TECHNICAL BULLETIN TB06-2022

INSTALLING TRON 40VDR AIS INTO FB-40 BRACKETS , NEW OR PREVIOUSLY USED FOR TRON 40VDR

FB-40/ Tron 40VDR AIS:

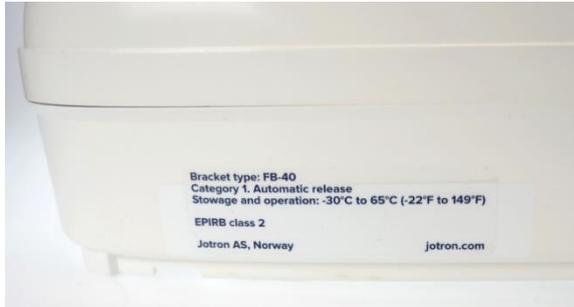
- If any of the above-mentioned spare kits are purchased, the label kit shown above in the center picture shall be used to re-label old FB-40 brackets to correctly show relevant information when Tron 40VDR AIS is mounted within. The two bracket pictures on the left side of the label kit above are two variants of brackets delivered with Tron 40VDR, while the two bracket pictures to the right are the same brackets after label kits are mounted. More in detail below.
- Pictures below show with old labels on left and righthand side of brackets lower part

The old and new labels may look almost the same, but with important difference in new Release tab and procedure on new label

Float free bracket FB-40, new or previously USED FOR 40VDR can be relabeled using the label kits included in the below Tron 40VDR-AIS spare part kits:

Before attaching the new labels, clean with Isopropanol / Isopropyl alcohol on all area's labels shall be fitted.
